SERVICE BULLETIN

1107261-25-01

EQUIPMENT FURNISHINGS - CHAPTER 25
INTEGRAL BUCKLE ASSEMBLY, PART NUMBERS 1107261-01, -05, -09
REPLACE LOWER COVER 1107270-01 WITH COVER ASSEMBLY 1107525-01

**Integral Buckle Assembly (Typical)
Figure 1**

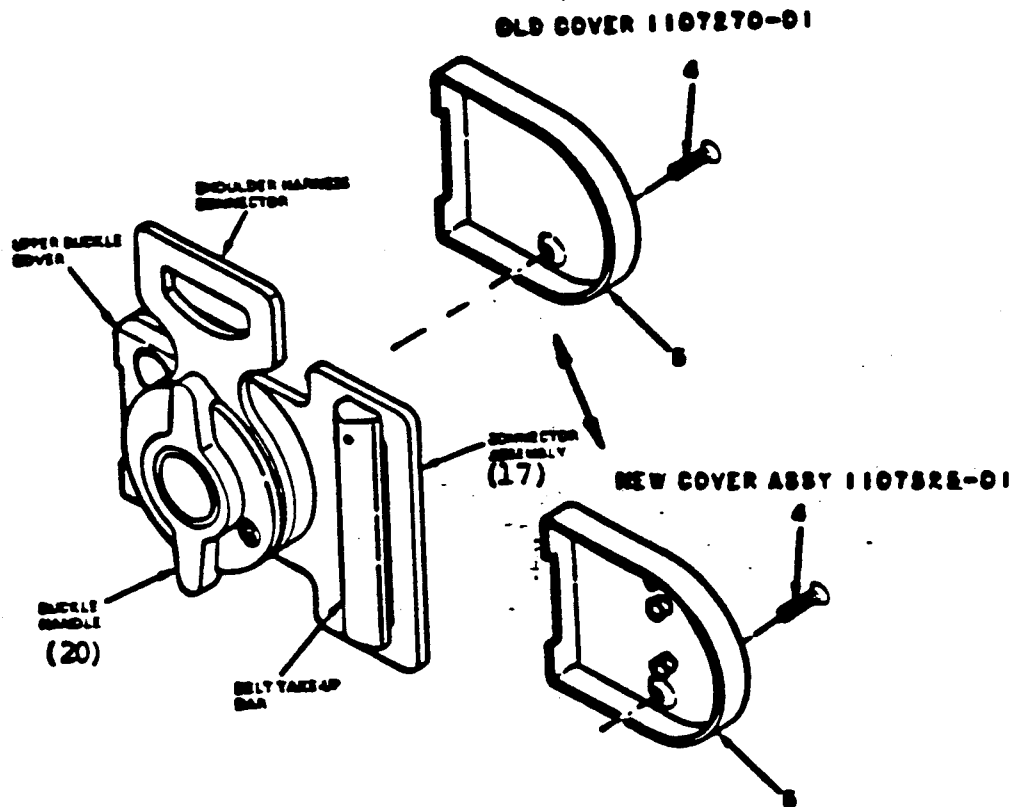
This Service Bulletin is issued to provide a secondary feature into the buckle assembly to eliminate the possibility of the buckle assembly not releasing while in the unlatched position. It has been determined that the replacement of the lower cover with a cover assembly that incorporate two (2) mechanical stops, to prevent over rotation of the cam plate, will insure that the cam plate cannot over rotate.

- (1) Hold buckle assembly in one hand with buckle handle (20) downward.
- (2) Remove screws (4) to free lower buckle cover (5) from connector assembly (17).
- (3) Remove buckle cover (5) and discard.

- (1) Place new cover assembly (5) in place on connector assembly (17).
- (2) Apply Loctite (Grade B) to threads of screws (4) only and secure cover assembly to connector with screws.

- (3) Stamp or mark a suffix letter "M" to part number on each lap belt and on inertia reel nameplate. This will indicate accomplishment of this service bulletin.
